Technical Service Bulletin

92 Headlight washer jet does not retract

92 24 39 2065982/3 August 27, 2024. Supersedes Technical Service Bulletin Group 92 number 23-34 dated March 3, 2023 for reasons listed below.

Figure 3. Headlamp washer cylinder mounting bracket screws.

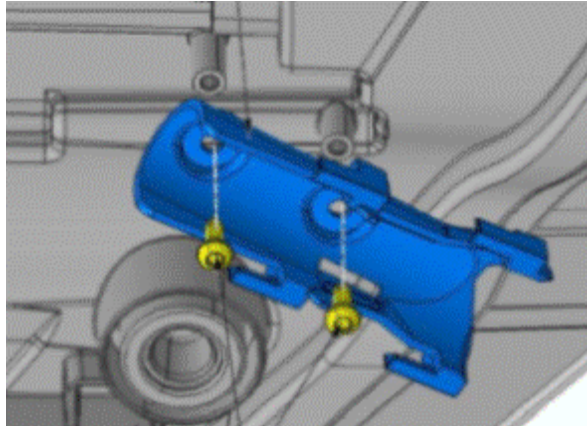
2. Additionally, a small adjustment can be made to the position of the headlamp washer cylinder by loosening the two washer cylinder mounting bracket screws (Figure 3) and rotating it such that the nozzle end is rotated away from the center line of the vehicle toward the turn signal lamp on the respective side being serviced (Figure 4). Tighten the screws in the adjusted position.

Figure 5. Old version cover spring clip.

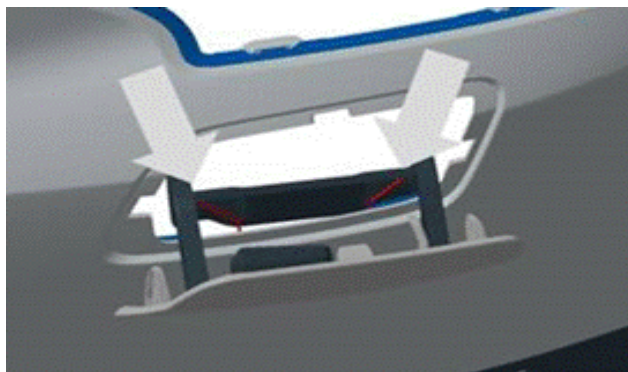
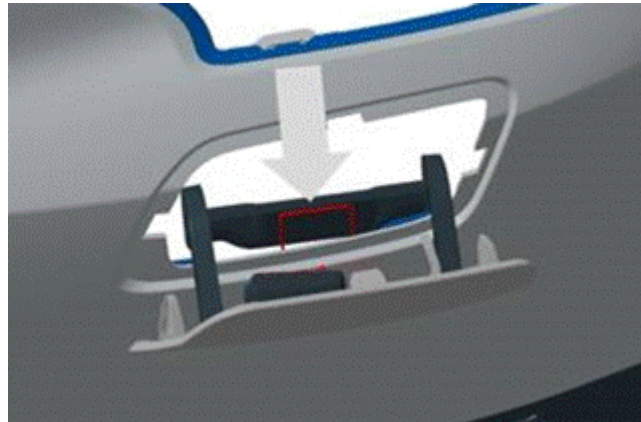
4. Make an attempt to relieve the pressure exerted on the headlamp washer system nozzle cover with your finger. If the nozzle retracts on its own check the cover spring clip version. Figure 5 shows the old version which has been found to exert excessive pressure and prevent smooth nozzle retraction.

5. Figure 6 shows the improved spring clip with reduced tension.

6. If the old spring clip version is installed and the nozzle retracts on its own after relieving the cover pressure, replacing the spring clip may solve the problem. Replace the spring clips for both the left and right sides in this case. Only the improved version spring clip is available.
7. If the nozzle does not retract after relieving the cover pressure and/or the spring version installed is of the improved type and all other inspections, adjustments, and repairs have been performed, continue root cause diagnosis as the solution specified in this TSB will not aid in solving the problem. Do not replace the headlamp washer cylinders as a replacement will not remedy this problem.
